SUBJECT: SUPPLEMENTAL COMMENTS ON SALT WASTE PACKAGE WORKSHOP

DOE/NRC observations of the Salt Waste Package Workshop held January 22-24, 1986 in Columbus, Ohio were previously provided to you. The following are supplemental comments on the final NRC and SRP presentations delivered on Friday morning, January 24, 1986 (see enclosed meeting handouts). The topics covered were:

DOE/NRC SALT WASTE PACKAGE WORKSHOP
January 22-24, 1985
Columbus, Ohio

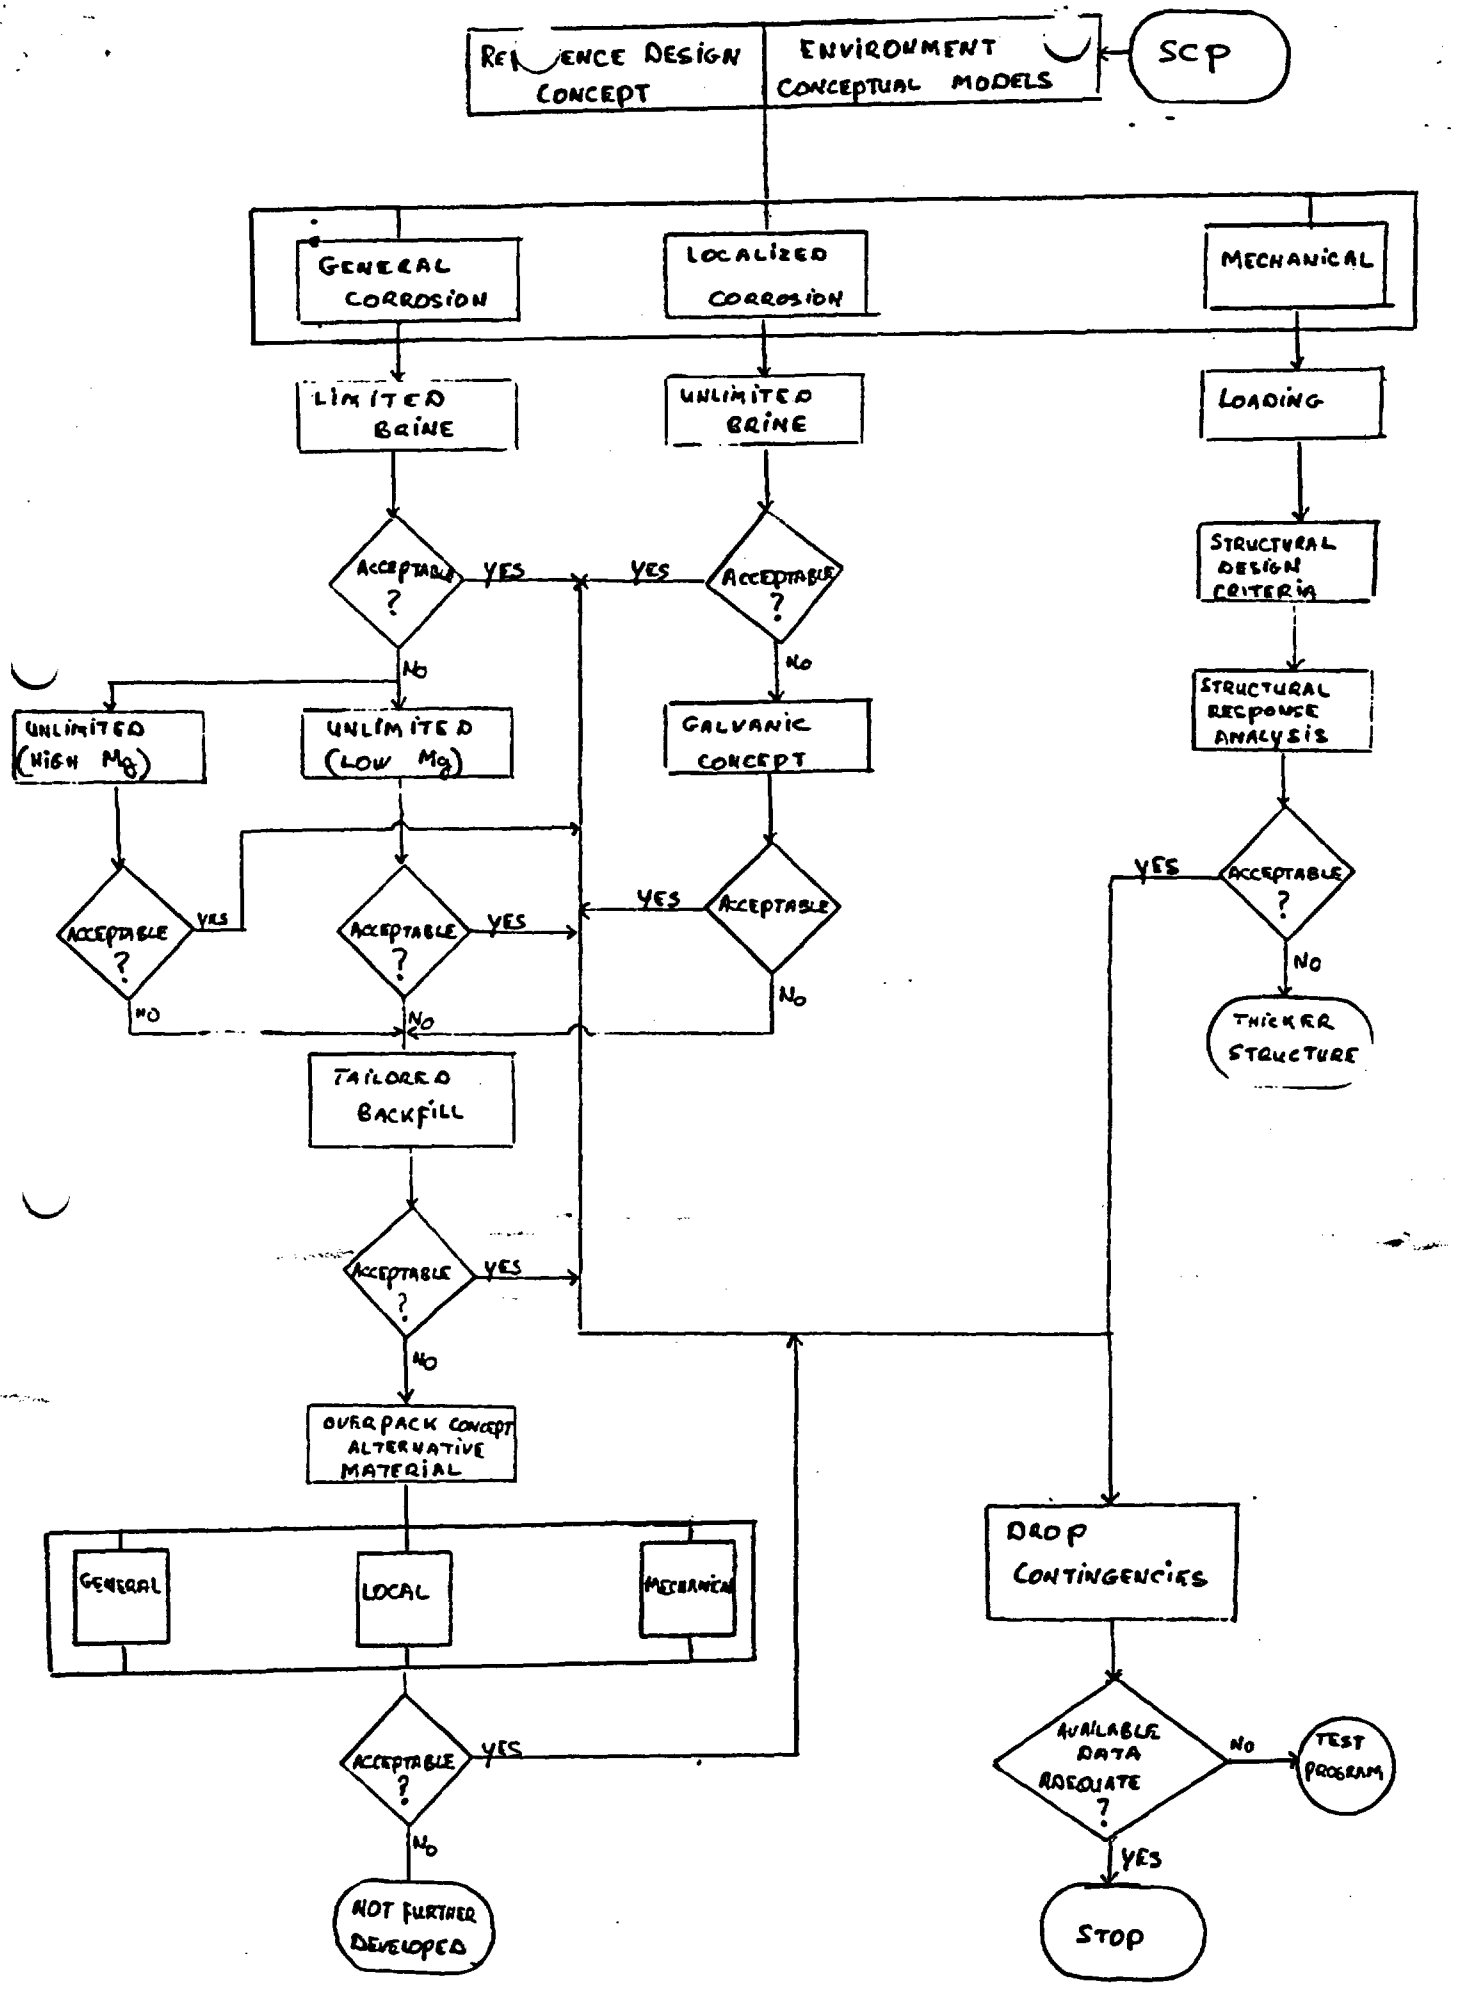
6. SRP Reference Design Flowchart - A flowchart outlining the logic of the SRP reference design was presented (see attachment). The flowchart is instructive, but does not consider scheduling difficulties that will be encountered in some of these flowpaths.
